**Town of Rotterdam
Planning Commission
April 4, 2023**

DPW Comments
April 4, 2023

- 1. VF Development, LLC (Contract Vendee) – 1859 & 1875 Altamont Avenue.** Final Site Plan/Special Use Permit Public Hearing review to construct a ±2,985 square foot Chase Bank branch with a drive-up ATM on a consolidated ±0.51-acre parcel. Engineer: ABD Engineers, LLP.

**RE: Chase Bank Site Plan Review
Town of Rotterdam, Schenectady County, New York
LaBella Project # 2231023.01**

GRADING & UTILITIES PLAN CHASE 1874 & 1879 ALMONT AVE. STATE OF NEW YORK COUNTY OF SHERIDAN CHASE ENGINEERS, LLP 515-777-0135 FAX: 515-777-0139 www.chase-engineers.com	
SHEET NO. 1 OF 2	PROJECT NO. 23-01

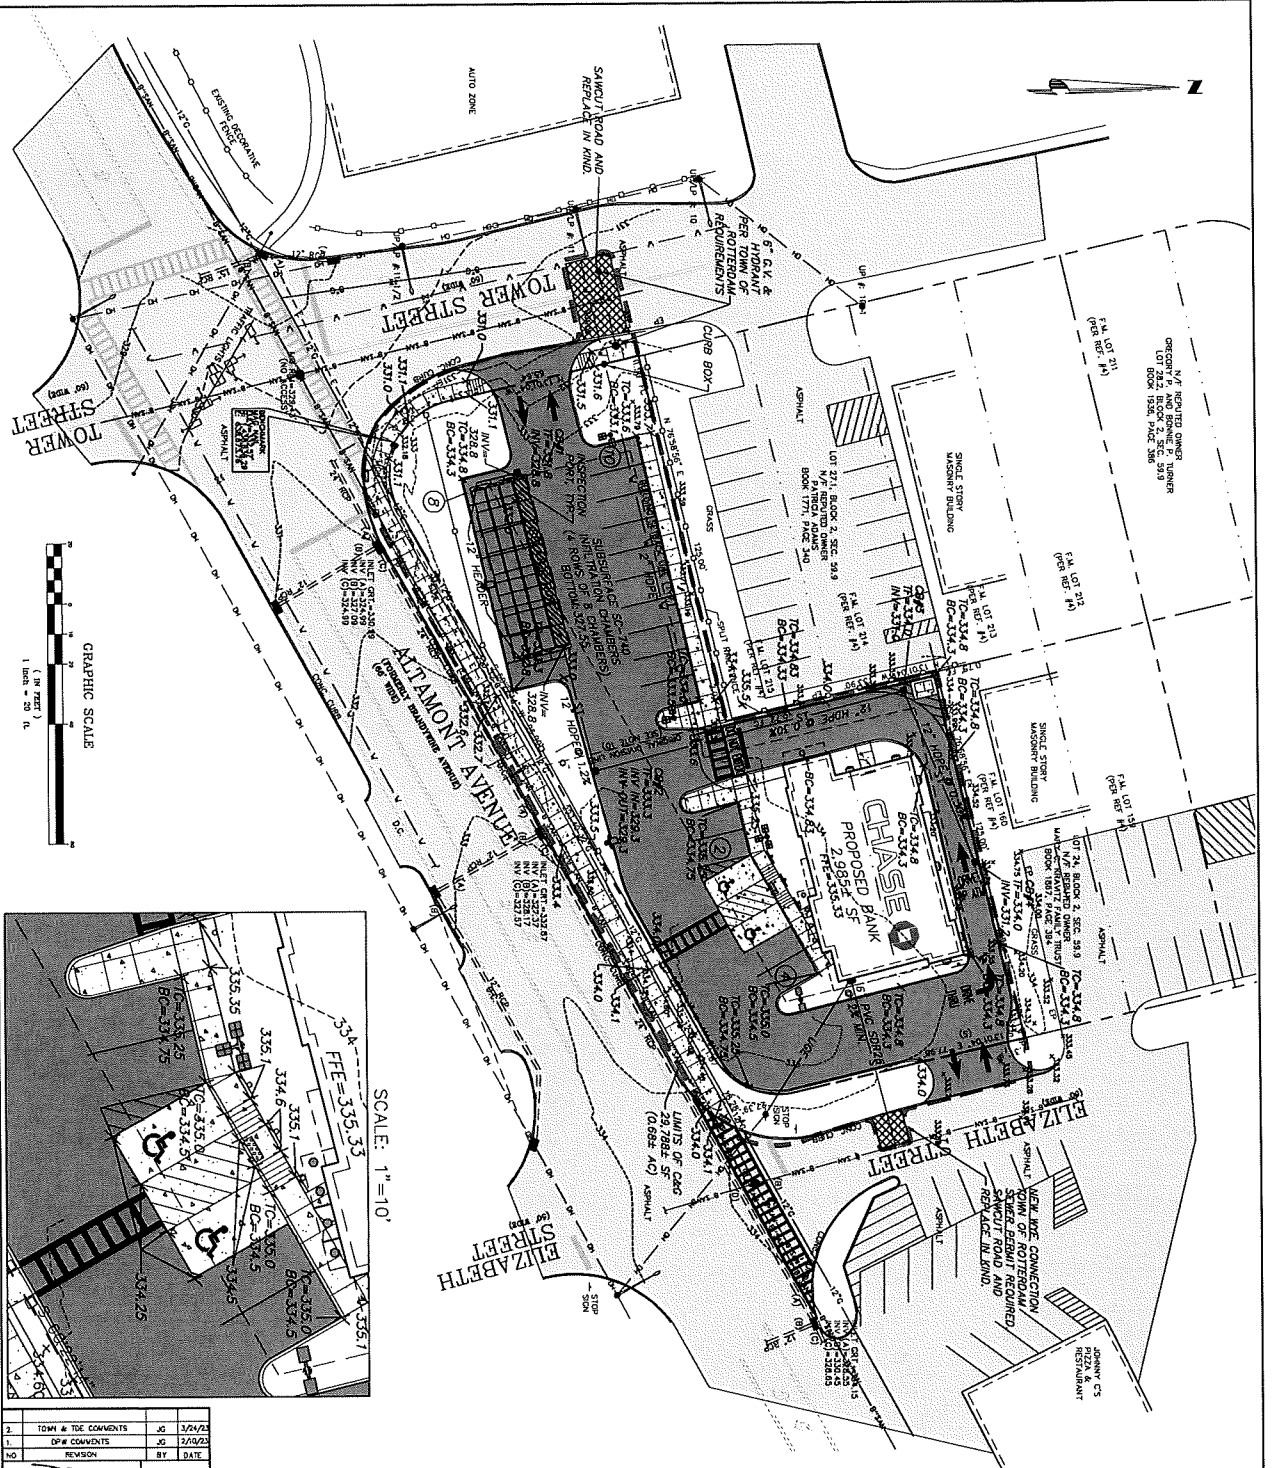
Final Site Plan	\$350.00
Advertising	\$41.48
Total	\$391.48
4. As requested by DPW, the applicant has added a fire hydrant to Tower Street. After further review, it was determined that given the distance, the water service and hydrant should be located along Elizabeth Street. The final site plan should be modified to relocate the hydrant and water service along Elizabeth Street.

5. Change handicap parking detail to 9' by 18' for both the access space and both parking spaces.
6. At a minimum, the existing utility connections for water and sewer to each building should be identified and shown on existing conditions and demo plan. These must be properly abandoned and the water services terminated at the main. These should be noted on the final plans.

7. Modify note #13 to read: "Existing water utilities shall be terminated at the main and verified by the Town DPW prior to the issuance of building permits."

EXISTING CONDITIONS & DEMO PLAN

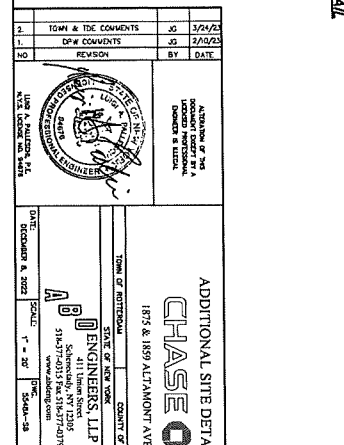
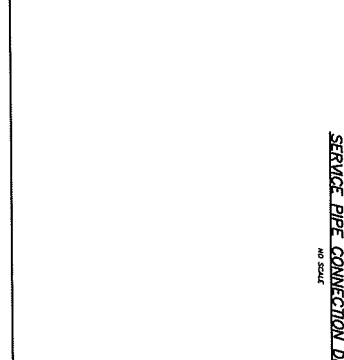
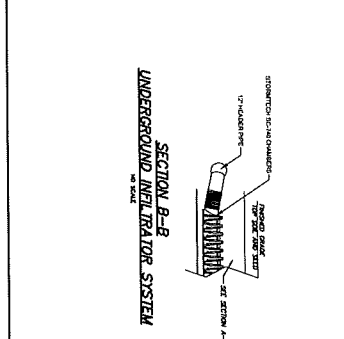
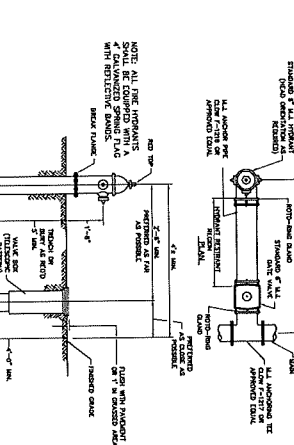
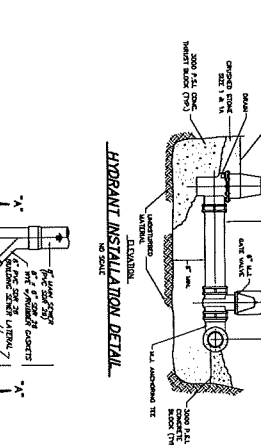
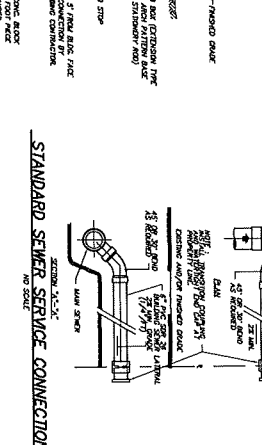
- WW-1.2 Correct the Demolition Note 2 on Sheet 4 to reference Town of Rotterdam.
- WW-1.3 The Applicant to revise the site plans to show all existing water and sewer utilities that are to be disconnected for both exiting parcels.

Note has been revised as requested.
